RE: Reinitiation of Consultation on Long Term Operations of the State Water Project and Central Valley Project

June 4, 2019 Letter to National Marine Fisheries Service regarding Biological Assessment for Reinitiation of Consultation on Long Term Operations of the CVP and SWP

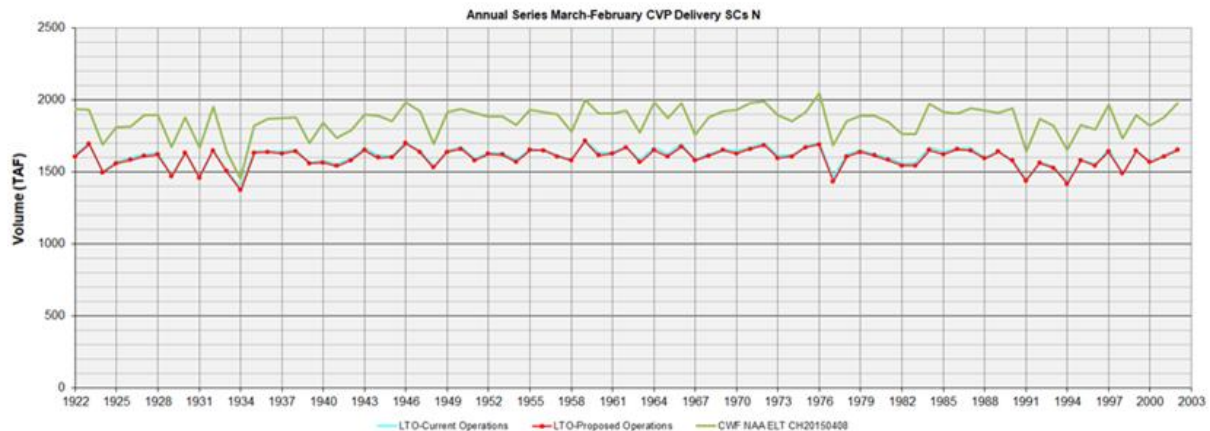
Unlike prior consultations and environmental reviews, this biological assessment only models the effects of recent historic levels of water diversions by Sacramento River Settlement Contractors instead of full contract amounts. The modeling assumptions in the BA explicitly states that the CalSim modeling only analyzes historic diversions by the Sacramento River Settlement Contractors, not the full contract amounts. *Id.*, Appendix D at 46 (“Land-use based, full buildout of contract amounts, except for Settlement Contractors represented with historical diversions.”); *id.* at 47.⁵

CalSim results from the BA also demonstrate that the Bureau of Reclamation changed the assumptions regarding the amount of water diversions by Sacramento River Settlement Contractors in both the Continued Operations Scenario and the Proposed Project. In recent previous ESA consultations and NEPA analyses the Bureau of Reclamation analyzed the effects of full contract amounts by the Sacramento River Settlement Contractors, including the California WaterFix biological opinions, California WaterFix Final EIS/EIR, and the 2015 Final EIS on Long Term Operations of the CVP and SWP. In contrast, here the Bureau of Reclamation has significantly reduced water diversions by Sacramento River Settlement Contractors in the model, limiting those diversions to historic levels rather than full contract

amounts. Staff from the U.S. Fish and Wildlife Service confirmed that the CalSim model results show a significant reduction in water diversions by Sacramento River Settlement Contractors as compared to the California WaterFix modeling, providing the graphic below, and that this was a result of changes in the assumptions. See Email from Derek Hilts to Doug Obegi dated March 28, 2019.

The Sacramento River Settlement Contractors have never diverted their full contract amounts, and in most years total diversions are only 75% or less of full contract amounts. As a result, this change in modeling assumption significantly altered the modeling results, including causing a significant increase in carryover storage in Shasta Reservoir as compared to those earlier modelling efforts.
